## TIMING GEAR BACKLASH

## CONNECTING ROD BEARING INSERTS

Fig. 2

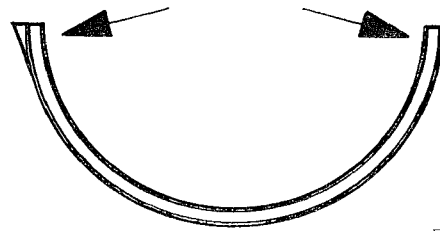
1600	engines - beginning with engine No. P-606 801
1600 S	engines - beginning with engine No. P-700 001
1600 S-90	engines - beginning with engine No. P-804 001

will be equipped with modified connecting rod bearing inserts. The spare part number for this new type has not been changed. The modified connecting rod bearing inserts are not readily reconizable.

The main feature of this modification is that the bearing inserts are by 0.02 to 0.035 mm thinner for a length of 7 mm, starting from the mating surfaces of both bearing inserts (see Fig. 2).

It is important to make sure that only the modified bearing inserts are used for the Type 1600 S-90 engines.
